# ***ROOF TRUSS ENGINEERING***

<b>APPROVAL FOR GENERAL COMPLIANCE WITH THE STRUCTURAL CONTRACT DOCUMENTS</b>
<input type="checkbox"/> <b>APPROVED*</b> Fabrication may proceed as shown.
<input checked="" type="checkbox"/> <b>APPROVED AS CORRECTED*</b> Fabrication may proceed based on noted corrections.
<input type="checkbox"/> <b>DISAPPROVED*</b> Fabrication may not proceed. Correct and resubmit.
<input type="checkbox"/> <b>REVIEWED FOR INFORMATION ONLY</b> Approval not required. Accepted for information purposes.
<input type="checkbox"/> <b>FURNISH ( ) CORRECTED COPIES</b>
<small>*Approval is for general compliance with the structural contract documents only. This approval assumes no responsibility for dimensions, quantities and conditions that pertain to fabrication and installation or for processes and techniques of construction.</small>
SIGNED <u>BRAD CARVILLE, PE</u>
DATE <u>10-07-24</u>

**332 NEW HAMPSHIRE  
COVINGTON, LA  
BEACH LUMBER, LLC  
SCI Job #209802**

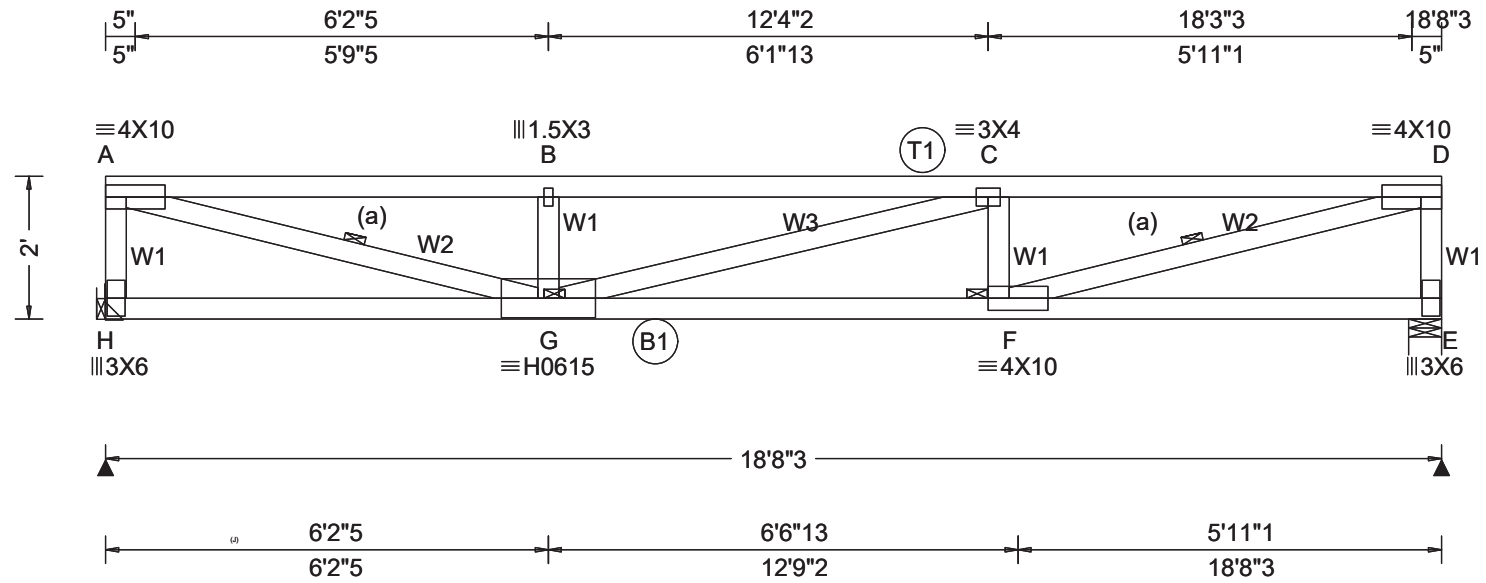
THIS TRUSS SUPPORTS MECH UNITS CU-1-3 AND RTU2. VERIFY THIS HAS BEEN ACCOUNTED FOR IN THE DESIGN
